NUCLEAR SAFETY RELATED

CONSTRUCTION	5-23-64
LIMITED CONSTRUCTION: AS NOTED	
PRELIMINARY NOT FOR CONSTRUCTION BIDDING PURPOSES	
DATE	RELEASED FOR PERIOD
THE CLEVELAND ELECTRIC ILLUMINATION COMPANY	
PERRY NUCLEAR POWER PLANT	
ELECTRICAL	
CABLE TRAY LAYOUT	
AUXILIARY BUILDING - WEST - EL. 500'-0"	
ENGINEER	CHAS. E. ADAMS, INC.
DESIGNED BY	CHAS. E. ADAMS, INC.
CHECKED BY	CHAS. E. ADAMS, INC.
DATE	5-23-64
PROJECT NO.	04-4549
DWG. NO.	D-264-222 K
SCALE	AS SHOWN

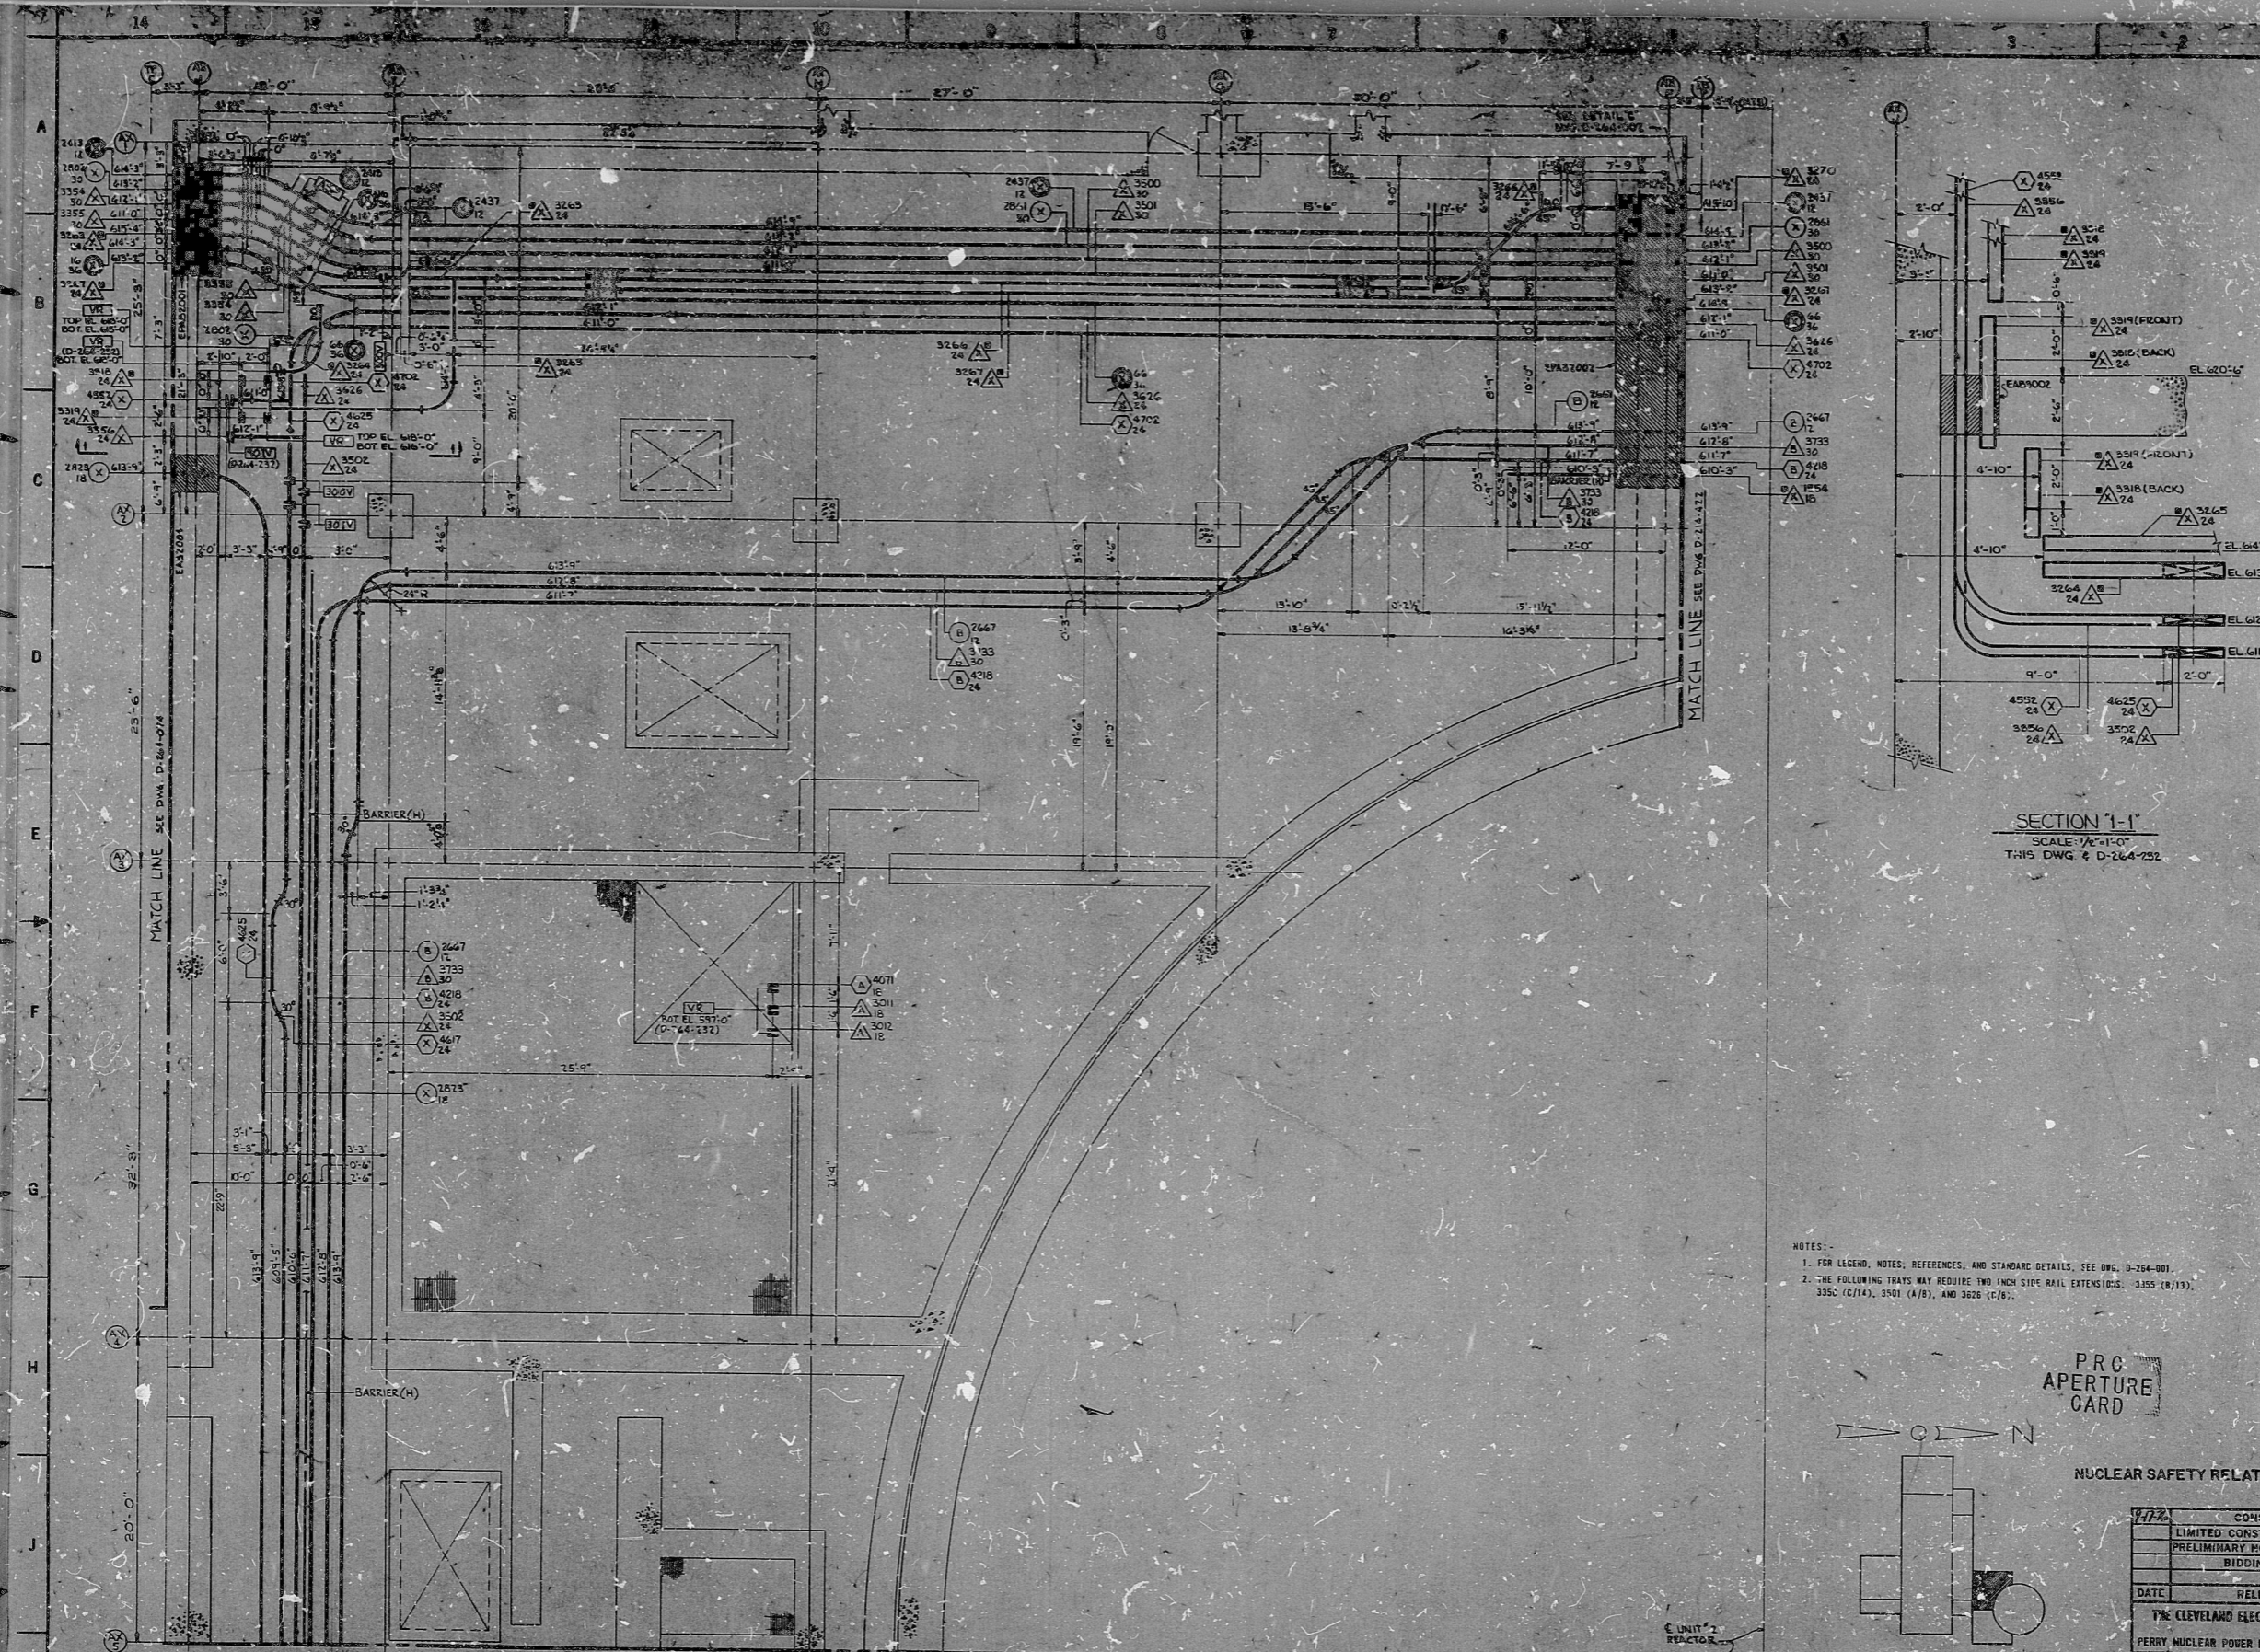
ADDED NOTE #2 AT COORD. 14-0

CHANGED TRAY #3266 TO 3270 A. COORD. 14-0. REVISED TRAY #3270 AT COORD. 14-0 AND AG AND TRAY #3266 AT COORD. 14-0 AS PER EQ #17074.

REVISED TRAY #3266 AT COORDS. B15 & C2.

ADDED TRAY #354 & BARRIERS AT COORDS. C-6, C-5, TRAY #367 AT COORD. C-7 THRU B-14. TRAY #3244 AT COORD. A-5. B-16 THRU B-14. TRAY #3265 AT COORDS. B-15, C-2, C-3, TRAY #318 AT COORD. C-10, TRAY #316 AT COORD. B-13, TRAY #364 AT COORD. B-15, TRAY #3265 AT COORDS. B-12, E-15, B-14 SECTION 1-1 AT COORD. E-3.

ADDED 6" TRAY GAPS AT COORD. B-12 AS PER ECN #1950-33-314. REVISED TRAY #2823 AT COORD. C-15 THRU J-15 AS PER ECN #145-35-756 & PER ECN #1950-33-314. TRAY #2667 AT COORDS. D-15, E-15 AS PER ECN #271-35-212.

DELETED TRAYS #3373, #3374 & #3375 AT COORD. A12 AS PER ECN #2138-33-165.

REVISED TRAY NUMBERS

REVISED TRAY #467 AT COORDS. F-10 & REVISED TRAY #425 AT COORDS. E-15-F15

ADDED DETAIL C REFERENCE AT COORDS. 15-0. REVISED TRAY #2451 AT COORDS. C-5, C-7, D-7, D-8, D-9, D-10, D-11, D-12, D-13, E-13, E-13, H-13, H-13. REMOVED TRAY #3001 AT COORD. F-7. REVISED TRAY #2021 AT COORD. F-10. ADDED TRAYS #467, #425 AT COORDS. F-10 & F-15.

REVISED ELEVATIONS OF TRAYS #2021, #336 & #70 AT COORDS. A13, A14, B13, B14. RELEASED #336 & #70.

ADDED OPENING BARRIERS AT COORD. C14 AND TRAY #146 AT COORDS. B-15, B-16, B-17, B-18, B-19, B-20, B-21, B-22, B-23, B-24, B-25, B-26, B-27, B-28, B-29, B-30, B-31, B-32, B-33, B-34, B-35, B-36, B-37, B-38, B-39, B-40, B-41, B-42, B-43, B-44, B-45, B-46, B-47, B-48, B-49, B-50, B-51, B-52, B-53, B-54, B-55, B-56, B-57, B-58, B-59, B-60, B-61, B-62, B-63, B-64, B-65, B-66, B-67, B-68, B-69, B-70, B-71, B-72, B-73, B-74, B-75, B-76, B-77, B-78, B-79, B-80, B-81, B-82, B-83, B-84, B-85, B-86, B-87, B-88, B-89, B-90, B-91, B-92, B-93, B-94, B-95, B-96, B-97, B-98, B-99, B-100.

REVISED TRAY DIMENSIONS & WALL THICKNESSES AT COORDS. A5, B5, C5 & D5. CHANGED OPENING BARRIERS TO EPABDOOT, EPABDOOT TO EPABDOOT & REM. NEC. BARRIERS. REMOVED TRAYS #146 & #147. ADDED TRAYS #1 & #10. ADDED TRAY #2523 AT COORDS. B13, C13, D13, E13, F13, G13, H13 & J13. REVISED TRAY DIMENSIONS AT COORD. E-3.

REVISED TRAY #146 AT COORD. E-3.
